**Response to Cabinet Comments on the Herrington Lake  
Corrective Action Investigation, Source Assessment, and Risk Assessment Report**

This document and the attached Addendum (Appendix A, *Corrective Action Investigation Source Assessment, and Risk Assessment [ISARA] Report- Coal Pile Addendum*) provide the responses to the January 31, 2020 Kentucky Energy and Environment Cabinet Department for Environment Protection (Cabinet) comments on the *Corrective Action ISARA Report* for the Kentucky Utilities Company (KU) EW Brown Station.<sup>1</sup> The Cabinet comments are shown in italics followed by the corresponding responses.

By letter dated January 31, 2020, the Cabinet provided comments on the Corrective Action ISARA report. This addendum to the Corrective Action ISARA Report (hereafter referred to as the Coal Pile Addendum) was prepared in response to Comment #4, which requested additional evaluation regarding potential impacts to Herrington Lake from runoff or groundwater infiltration associated with the coal pile and coal pile retention pond.

Coal Pile Addendum to the Corrective Action ISARA Report  
E.W. Brown Station, Herrington Lake, Mercer County, Kentucky

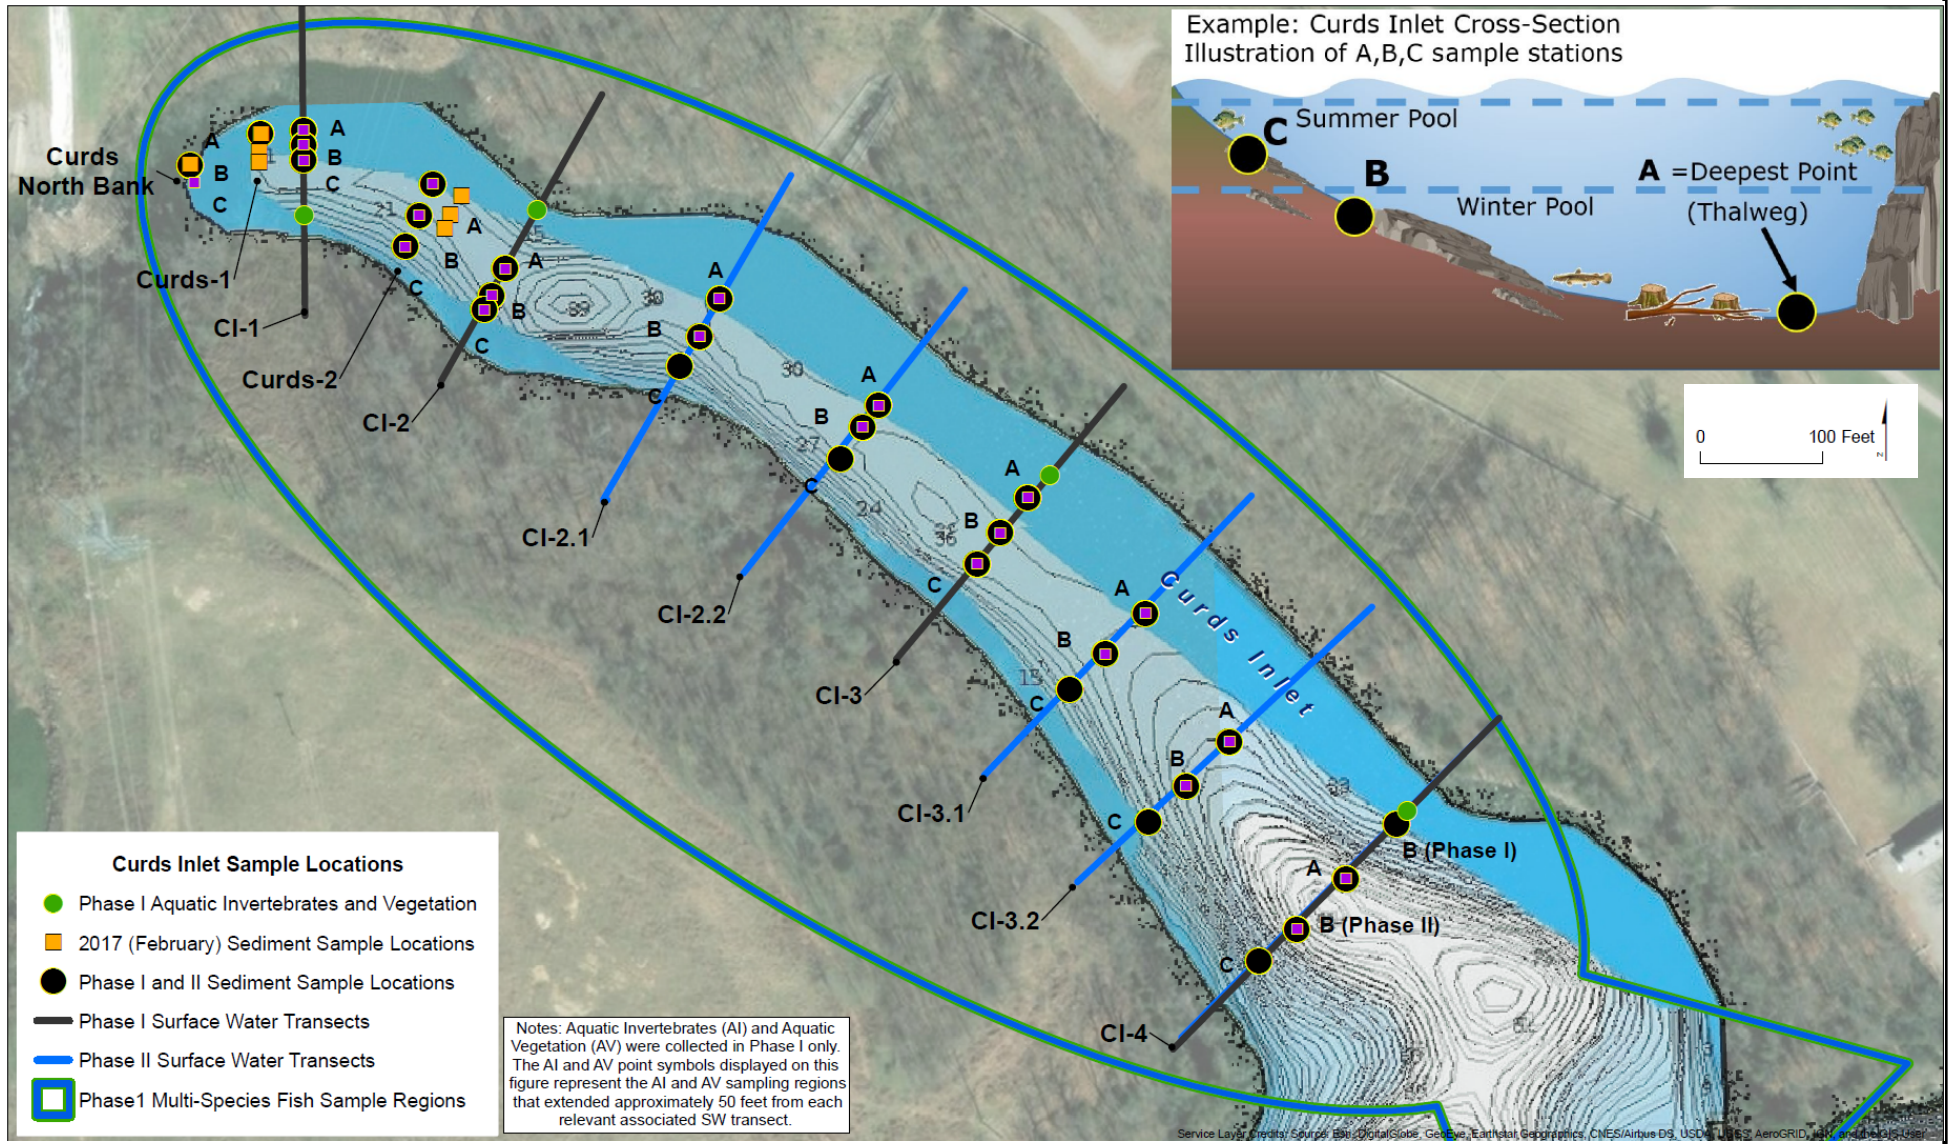
*Section 3.1.1 discusses and Figure 3-1J shows runoff collection for the coal pile along the northern edge of the stored coal. The ISARA asserts that drainage from the coal pile is collected in the coal pile runoff and settling pond. It is, however, unclear whether runoff shedding towards the south, for example, would be captured by this collection system. Additionally, it is unclear whether groundwater infiltration from this area is important to decision making in the SRAA. Ensure all potential runoff from the stored coal is adequately described and the basis of that description documented and presented to support the SRAA. Efforts such as, but not limited to, human reconnaissance of the area and drone or remote sensing photography of potential flow paths may be useful. Please provide a response in the errata.*

An addendum to the Corrective Action ISARA Report is provided in an Appendix to these responses (Appendix A) to address the coal pile and the coal pile retention pond as potential sources of coal-related constituents to Herrington Lake. This Coal Pile Addendum provides additional background information for the coal pile and the coal pile retention pond, describing:

- The location of the coal pile and coal pile retention pond relative to Herrington Lake.
- The geological and hydrogeological setting, which explains the conceptual model for how water from beneath the pond would migrate to the lake.
- An assessment of potential mass loading for selenium and arsenic in any seepage to Herrington Lake.

- A comparison of the coal-related constituent concentrations in the coal pile retention pond water, as a surrogate for potential exposure point concentrations, to water quality criteria for the protection of human health and the environment, and an evaluation of constituent concentrations in the lake at sampling locations closest to the coal pile.

The Coal Pile Addendum provided in the Appendix A concludes that there is no indication that coal-related constituents are migrating to Herrington Lake due to possible seepage to groundwater from the coal pile or the coal pile retention pond at concentrations or loadings that would pose an unacceptable risk to the environment or human health.
